INCH-POUND
MIL-DTL-22442/35B(AS)
Amendment 1
1 April 2000

DETAIL SPECIFICATION SHEET

CABLE ASSEMBLIES, AIRCRAFT AUDIO, CABLE

This amendment forms a part of MIL-DTL-22442/35B, dated 5 January 1998, and is approved for use by the Naval Air Systems Command, Department of Navy, and is available for use by all Departments and Agencies of the Department of Defense.

FIGURE 3. Test set-up.

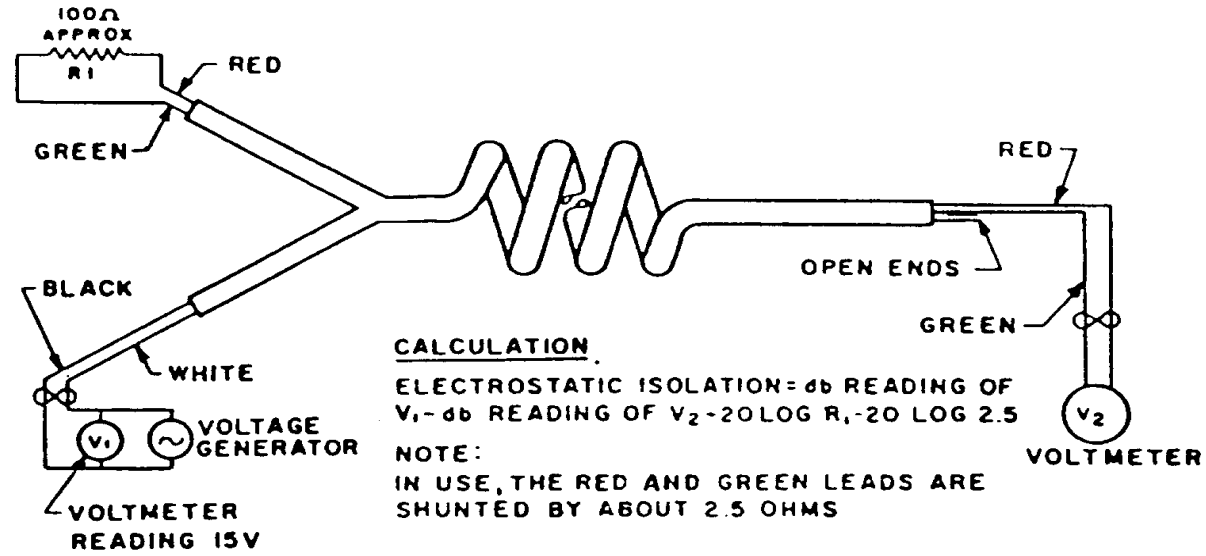
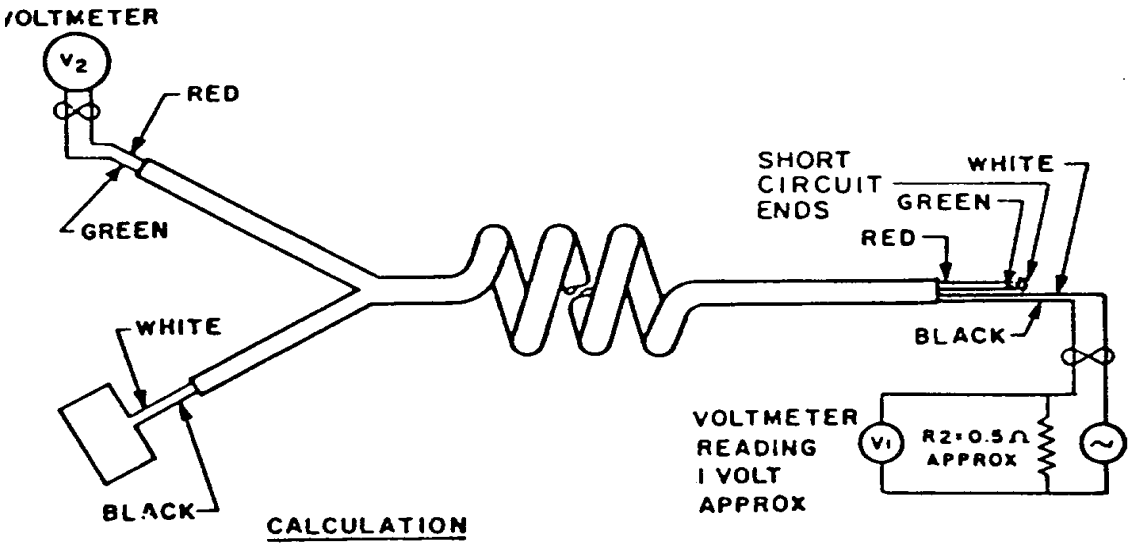
Add: 3.3.3.3 Electrostatic and electromagnetic isolation. The cord shall meet the electrostatic and electromagnetic isolation requirements listed in Table I when tested in accordance with Figure 3 and 4.7.

Add new Page: "Figure 3. Test set-up."

Add new paragraph: "4.8 Electrostatic and electromagnetic isolation. The cord shall be tested for electromagnetic and electromagnetic isolation to determine compliance with 3.3.3.3 and Table I when tested in accordance with figure 3."
